ADDENDUM NO. 3

COUNTY OF ERIE
DEPARTMENT OF ENVIRONMENT AND PLANNING
ERIE COUNTY SEWER DISTRICT NO. 6
CONTRACT NO. 68
LACKAWANNA OPEN CUT EXCAVATION SANITARY SEWER REPLACEMENTS

Issued: 9/25/2024

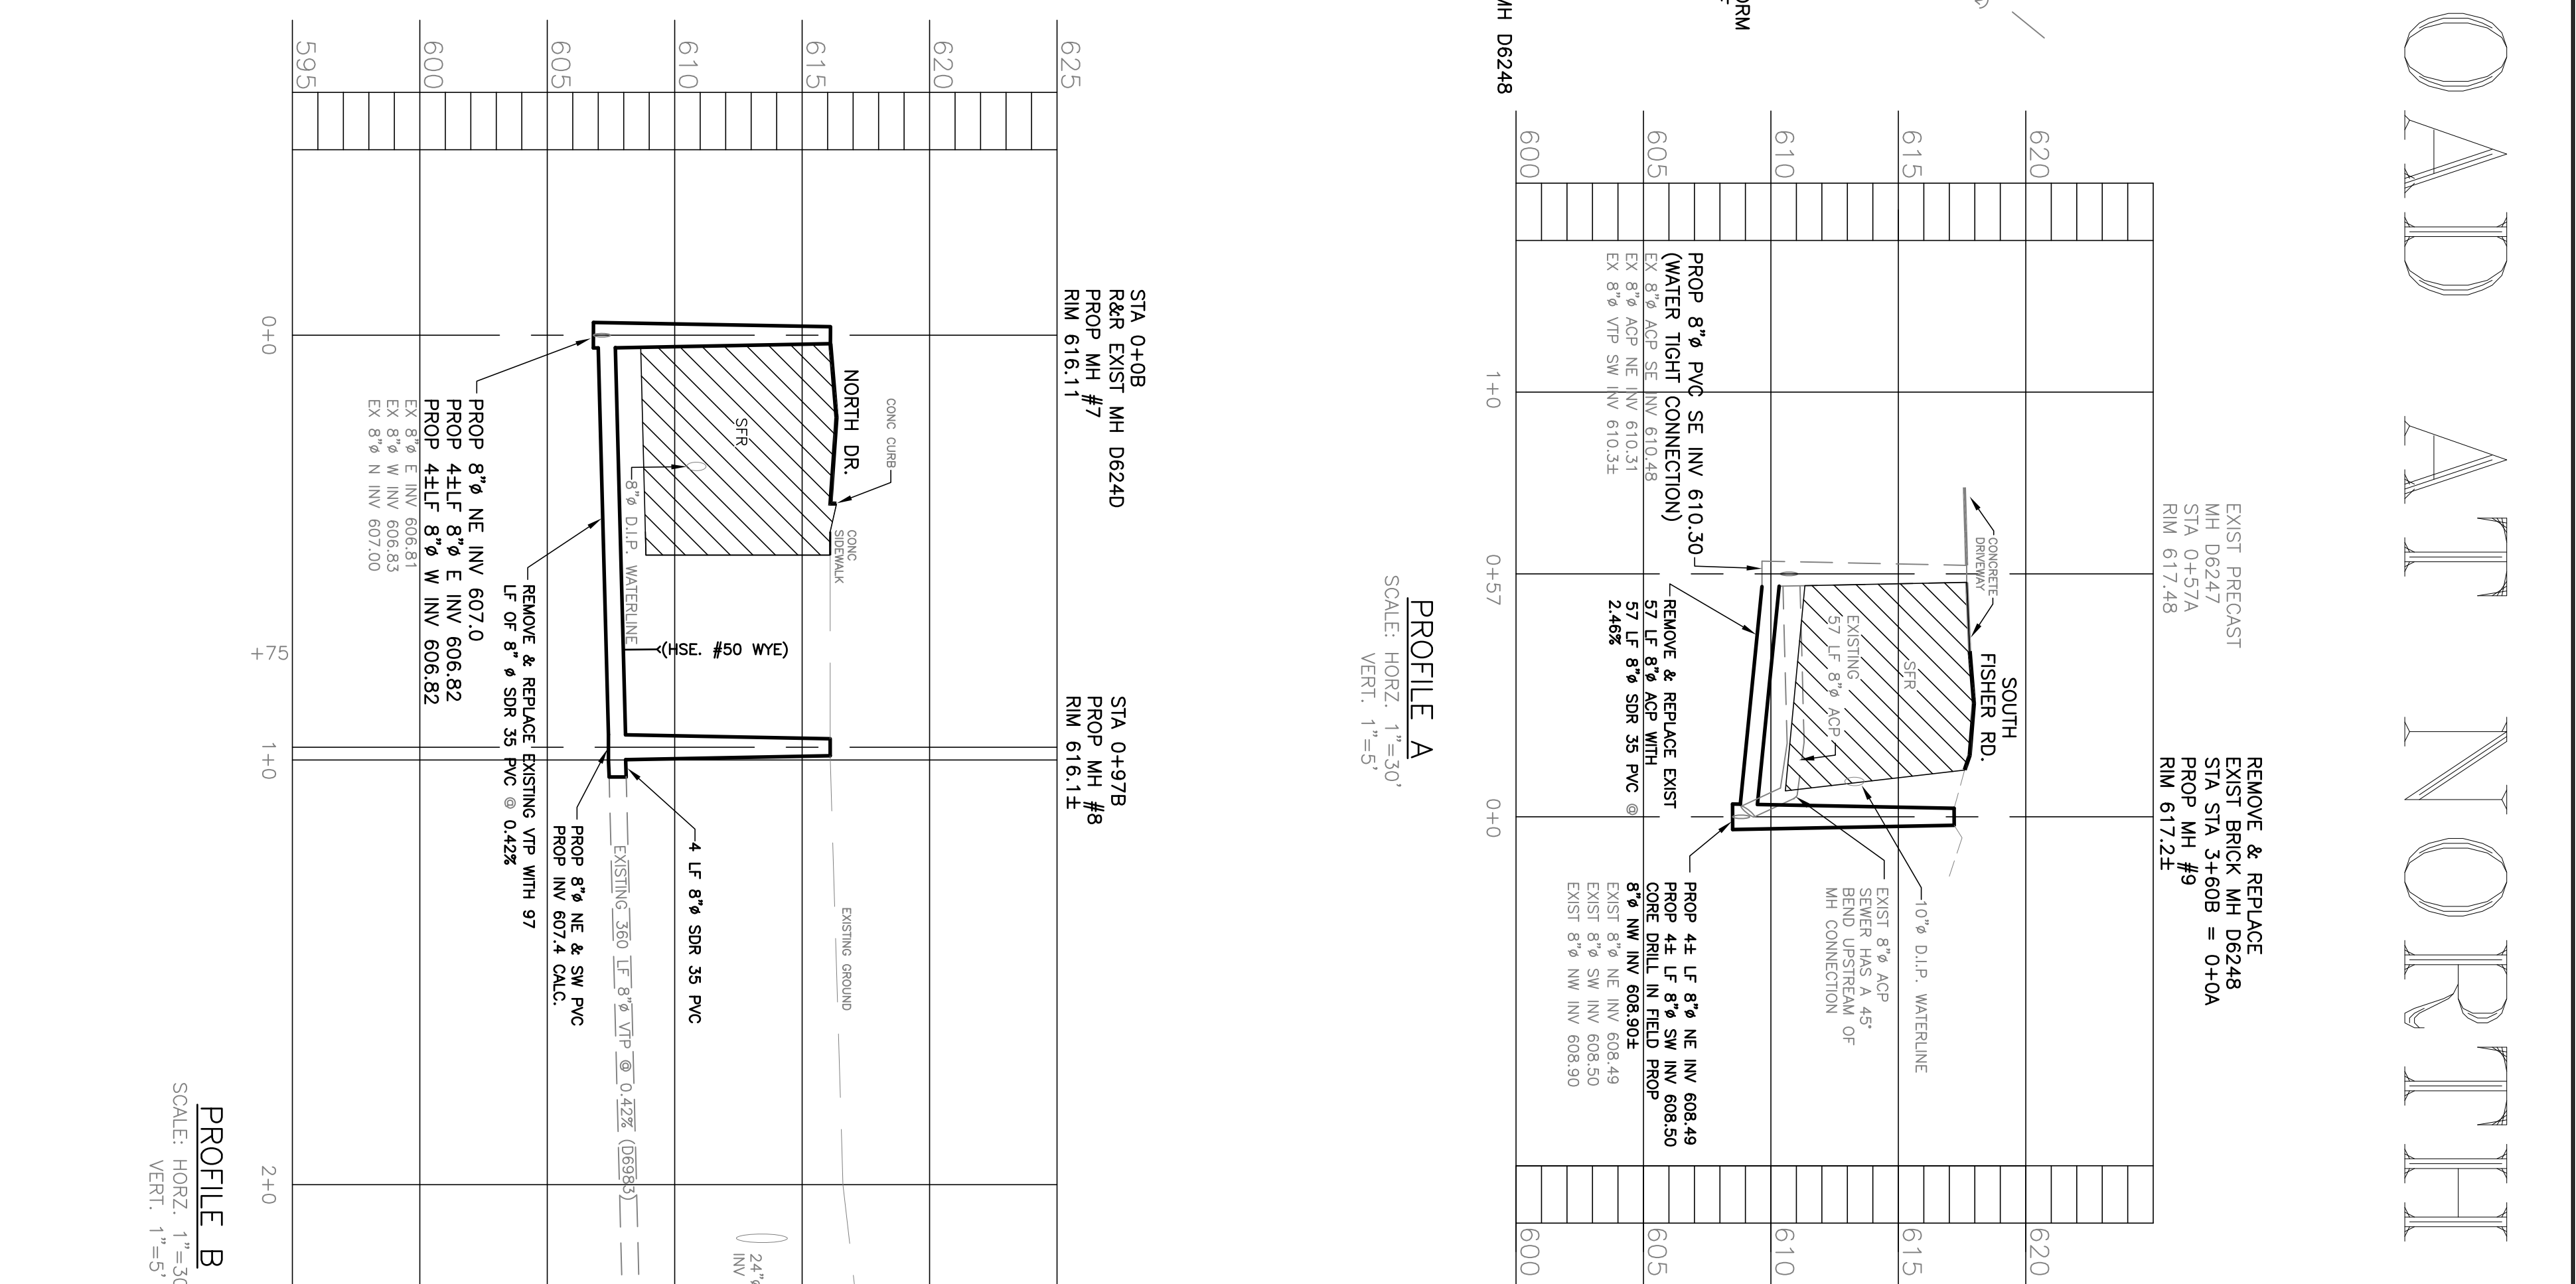
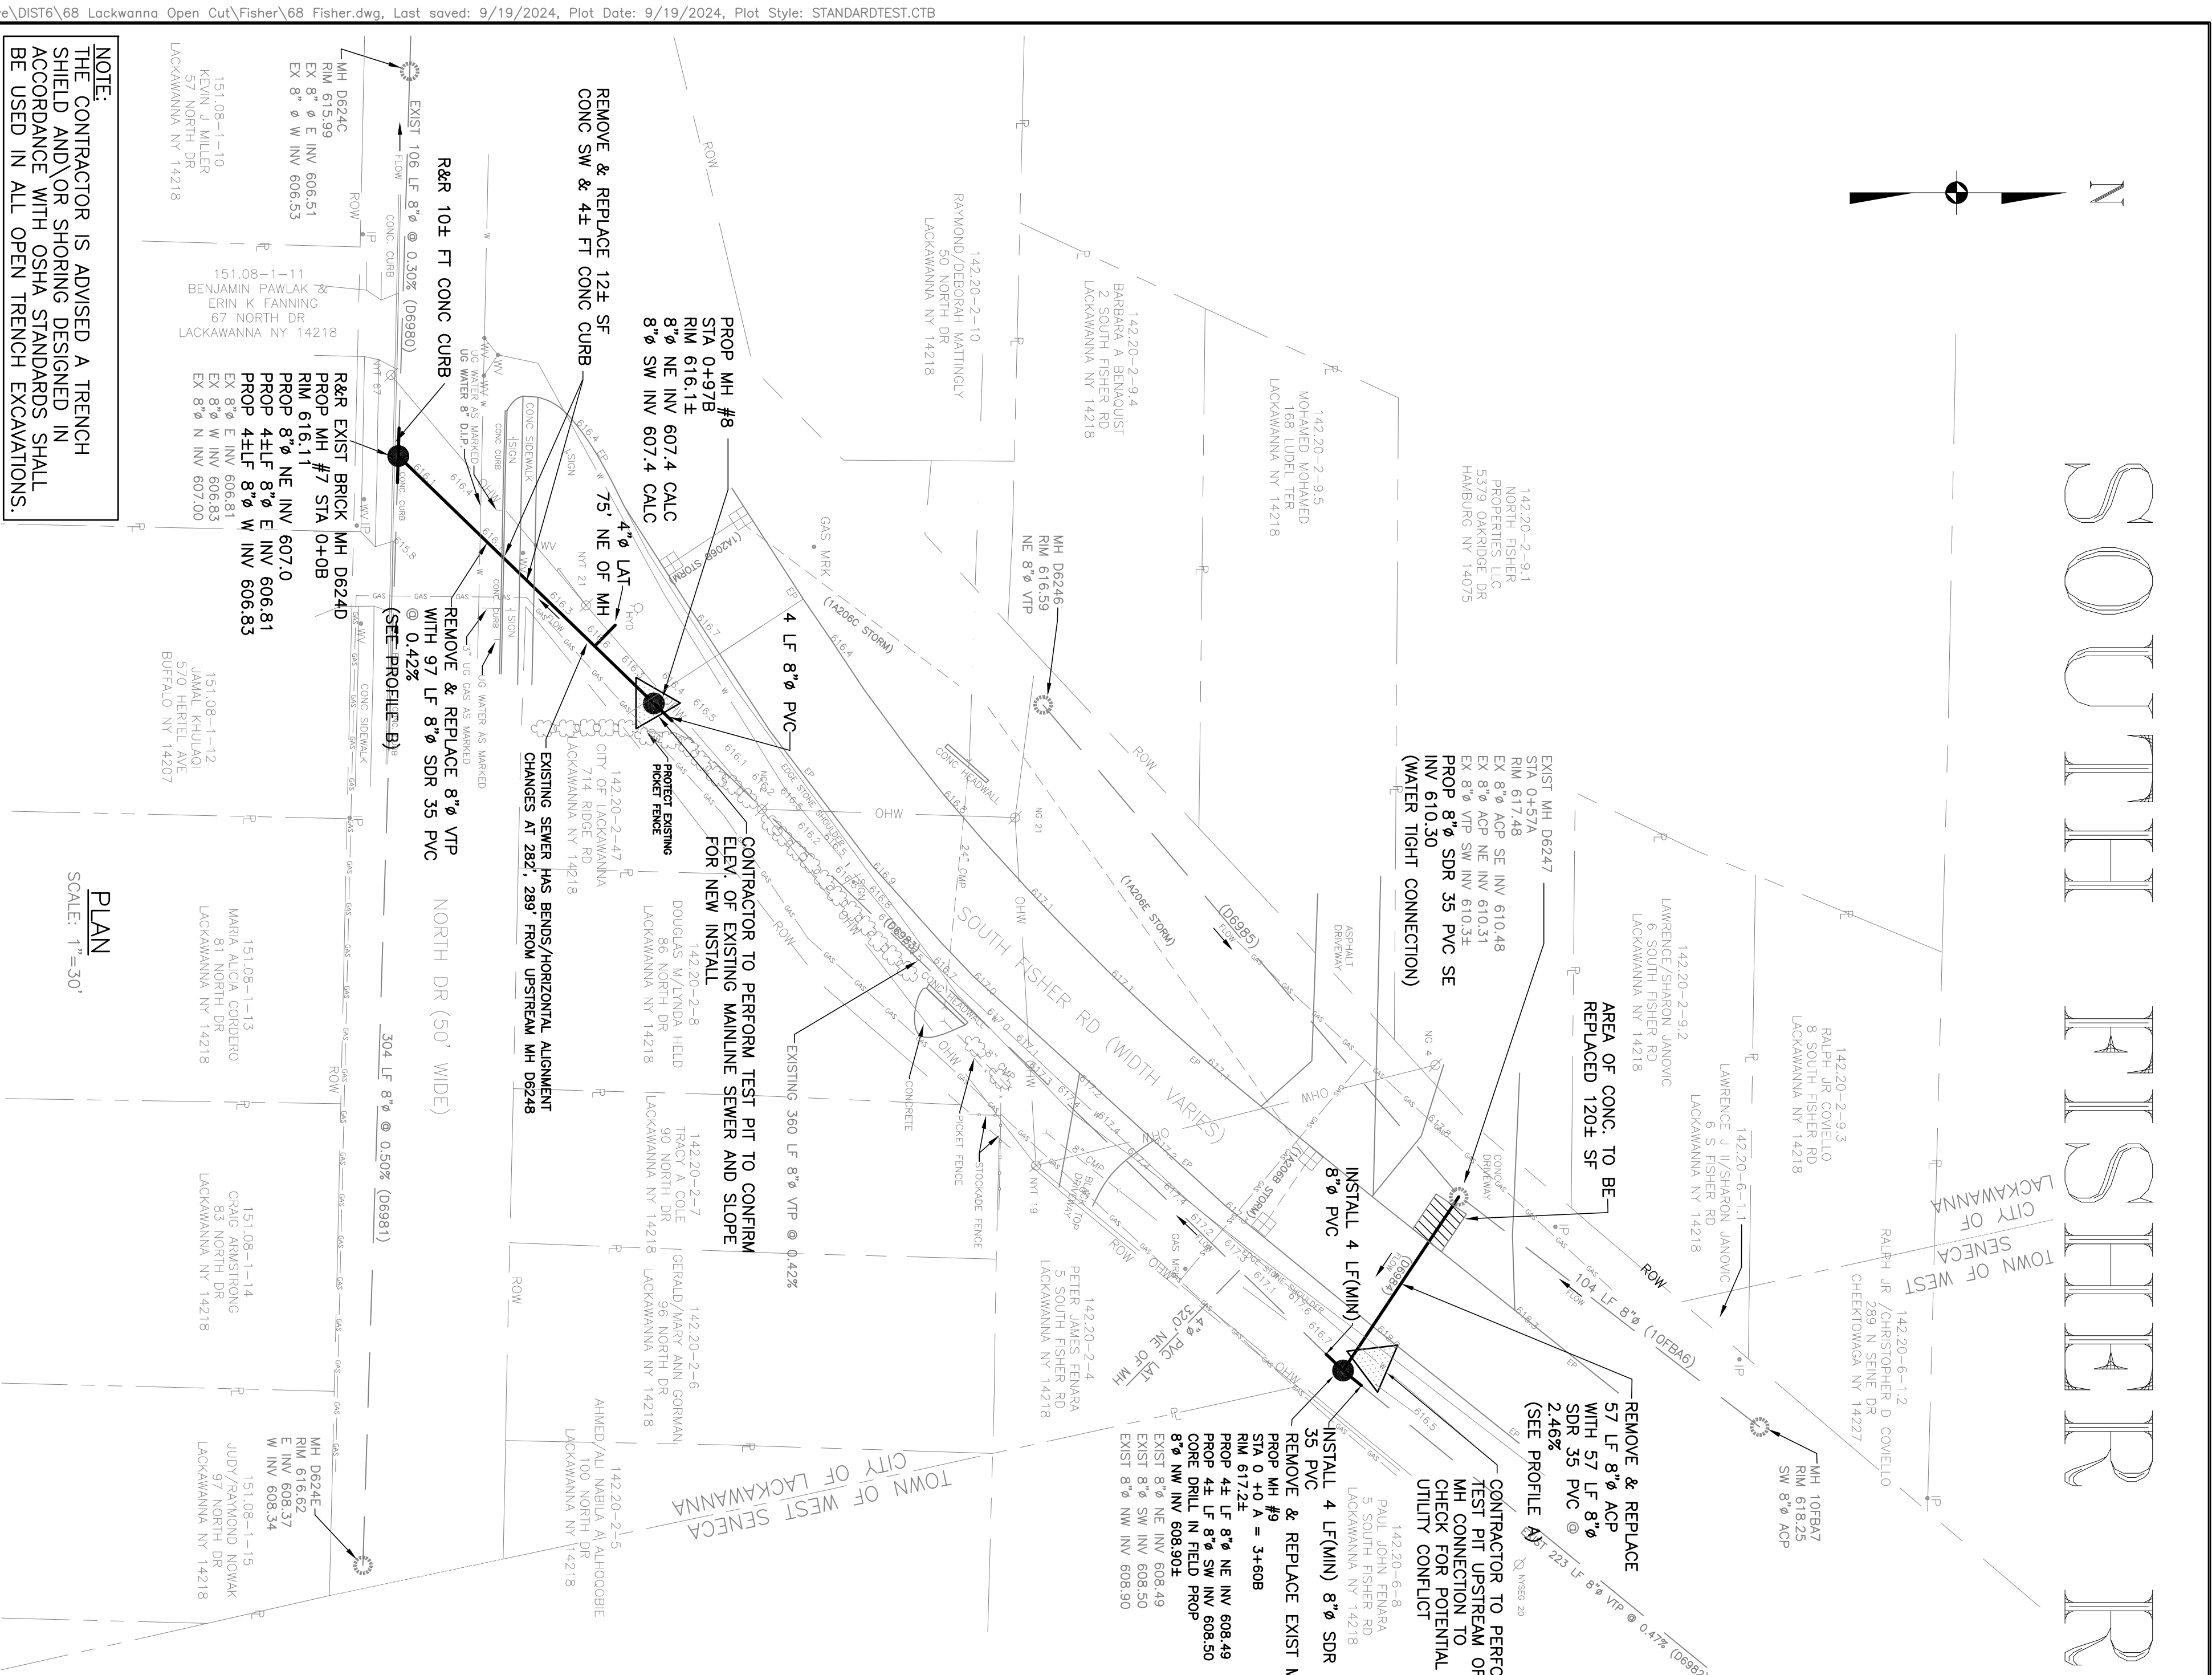
1. Plans, Sheet No. 4
 - **Replace entire Sheet No. 4 with enclosed revision which includes additional water and gas utilities.** (1 page)
